Campaign – Hinge Fastener Replacement

MODIFICATION INSTRUCTION

Bulletin No. 2016-1

2014, 2015 EBB-40, EBB-60 trailers

Symptom description

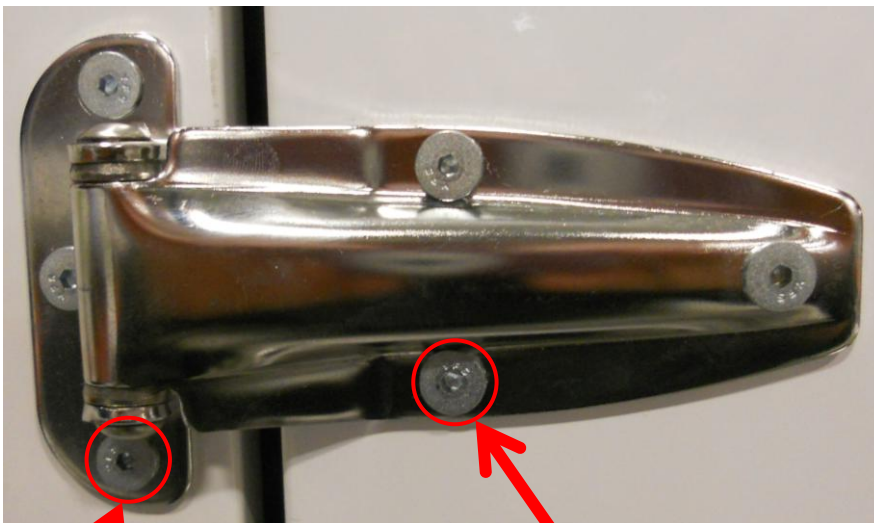
Isolated incidents of individual screw failure have been identified on the door hinge assemblies fitted to trailers

Screw heads may be found missing on hinge assemblies

83900.698 screw kit

Remove screws from one hinge at a time and replace with supplied parts. Torque value for each fastener is 41 in-lb or 3.5 ft-lb.

Note that original screws on this side may be secured from behind with machine nuts. If so equipped, nuts may be reused.

New screws (depicted) require a 0.125" hex tool. Recommended torque 41 in-lb or 3.5 ft-lb.
